Southern California Edison Company

Subject: Docket No. 50-206
Seismic Evaluation of Piping
San Onofre Nuclear Generating Station
Unit 1

SCE COMMENTS ON EGG-EA-6365

ATTACHMENT - 1
(ORIENTATION OF PIPE SUPPORTS)

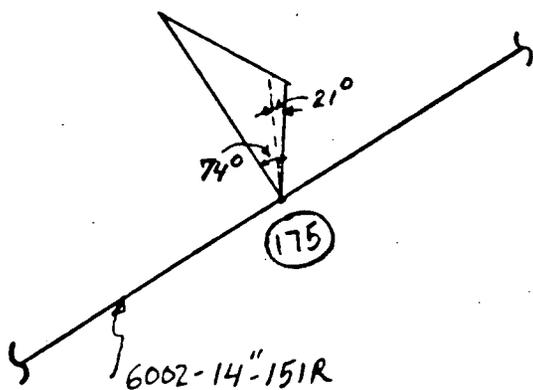
1. EG&G modeling of the orientation of five supports is not consistent with the pipe support drawings (see attachment I). One of the supports, S1-06-6002-H008, was oriented in the EG&G analysis input in such a way that it represents a vertical support instead of a support in the N-S direction. Hence, there is no support in the EG&G model for approximately 56 feet in the N-S direction. This results in a piping system which is overly flexible. In accordance with the applicable stress isometric and support drawings, this support is located approximately 34 feet west from hanger S1-05-6005-H023.

- PER DWG. S1-06-6002-H008, REV. 0, 7/31/82
- EG&G MODELED IN THE ANALYSIS
